## Quick feedback on Rain Forest Parkway speed bumps

**Proposed speed bumps on Rain Forest Parkway between Providence and Range Line.pdf**  
1085K

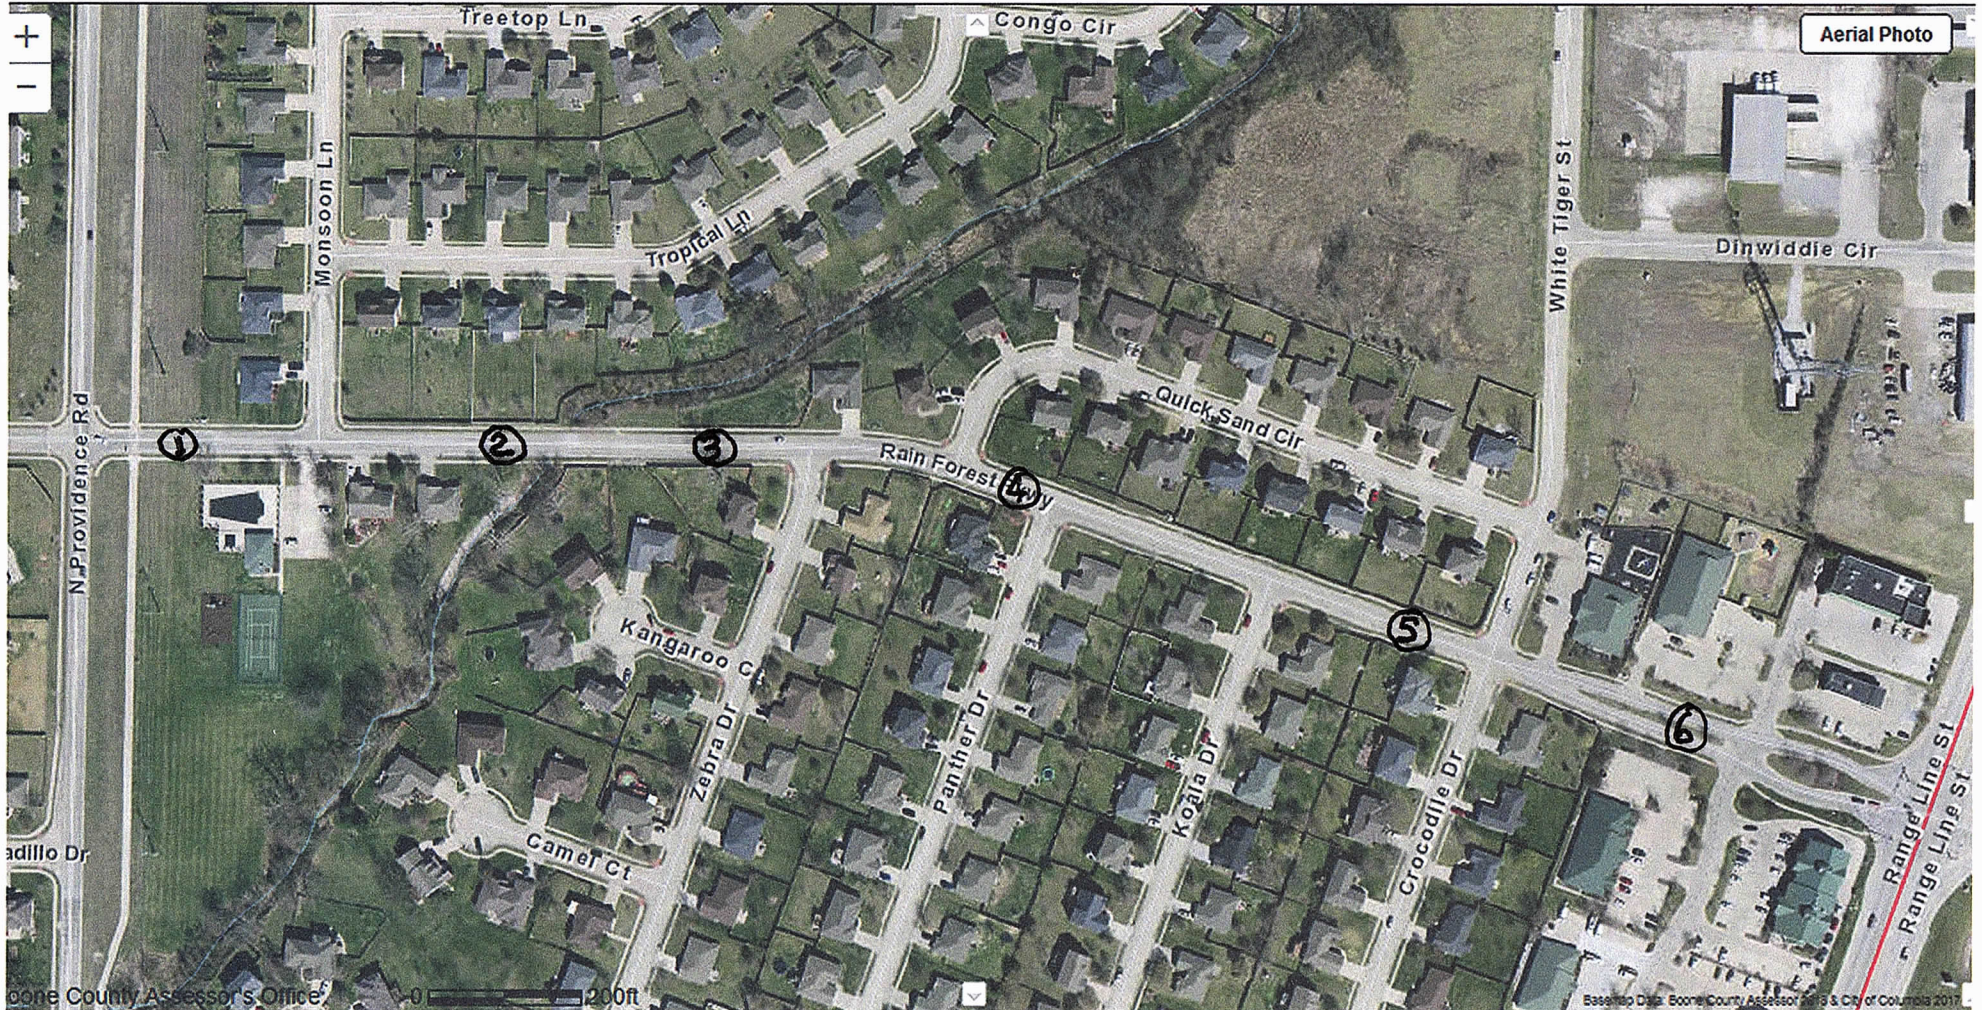
- ① NEW 25mph SPEED BUMP SLOWS TRAFFIC AT EASTBOUND ENTRY
- ② EXISTING 25mph SPEED BUMP
- ③ EXISTING MEDIAN
- ④ PROPOSED 25 MPH SPEED BUMP SLOWS WESTBOUND TRAFFIC AT BOTTOM OF HILL
- ⑤ PROPOSED 25 MPH SPEED BUMP " " " AT RESIDENTIAL ENTRY
- ⑥ POSSIBLE 25 MPH SPEED BUMPS (1 EACH LANE) SLOW ENTRY / EXIT TRAFFIC NEAR INTERSECTIONS

AT \$4K @ BUMP, COUNTING ⑥ AS TWO BUMPS, \$20K TOTAL COST

ANOTHER BUMP BETWEEN ④ + ⑤ COULD BE ADDED LATER BUT HOPEFULLY NOT NEEDED!
